Integrated Resource Planning

STAKEHOLDER FEEDBACK: July 2025

Stakeholder: Bruce Landrey

Organization: Landrey & Company, Inc.

Figure 89. Annual incremental revenue requirement by tax scenario (\$k)

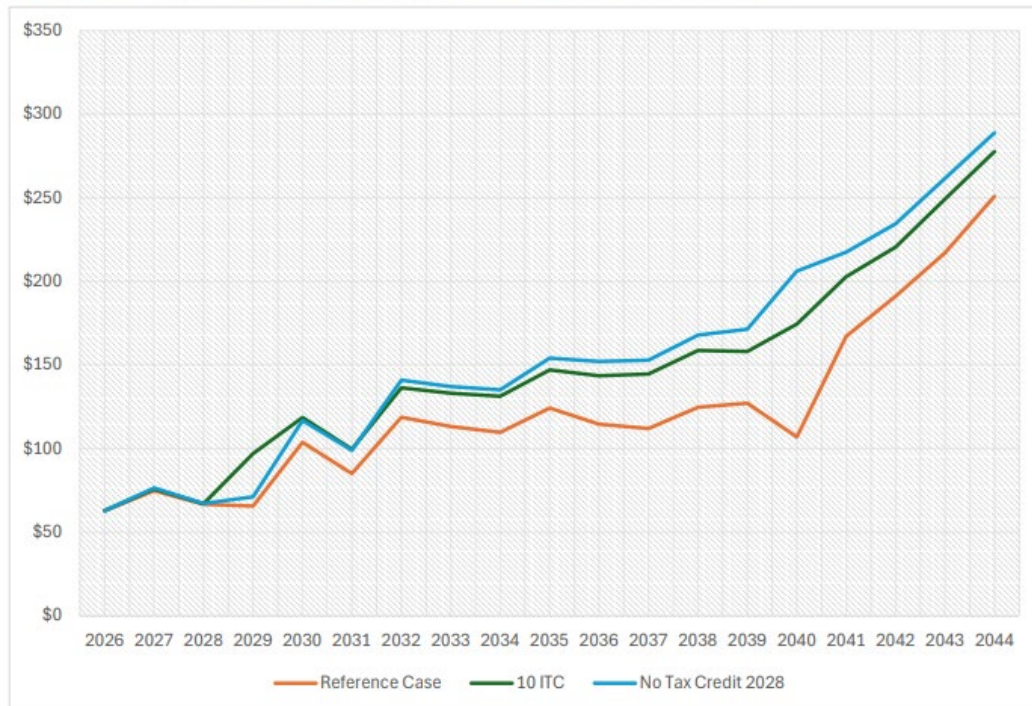
Am I reading the following correctly:

[Figure 89](#) – incremental revenue requirement increases by \$9-10 billion annually by 2044

The values in Figure 89 represent the total revenue requirement associated with IRP costs in each year, excluding baseline existing resource costs. The ~\$9-10 billion shown in 2044 reflects the total amount of costs that the IRP forecasts would need to be recovered in 2044 for this resource portfolio. The term “incremental” here refers to costs above and beyond the existing portfolio and other revenue requirement costs.
